#PIT5374: Headlight Performance (BCM Calibration and Bulbs) - (Feb 27, 2015)

Subject: Headlight Performance (BCM Calibration and Bulbs)

Models: 2015 GMC Sierra

2014 GMC Sierra 1500

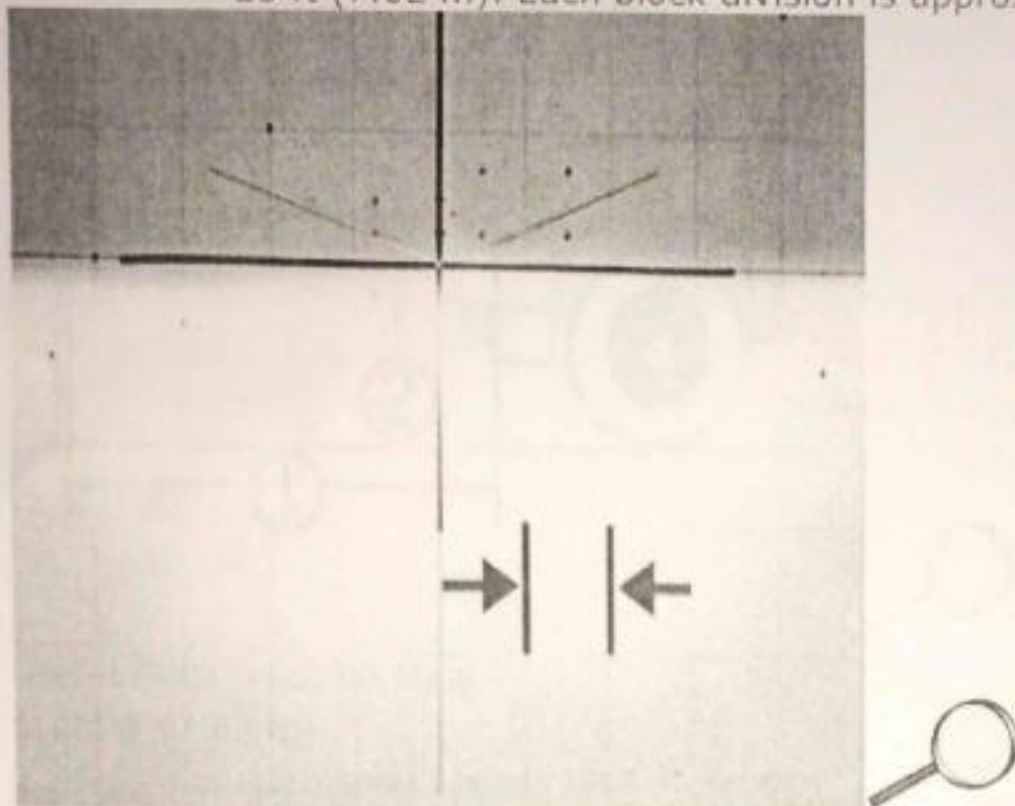
2. Replace both headlight bulbs with updated bulb part number 23342527. **IMPORTANT:** Verify the correct bulb is being installed by confirming the following markings on the bulb:

1. 28432

2. HIR2+30
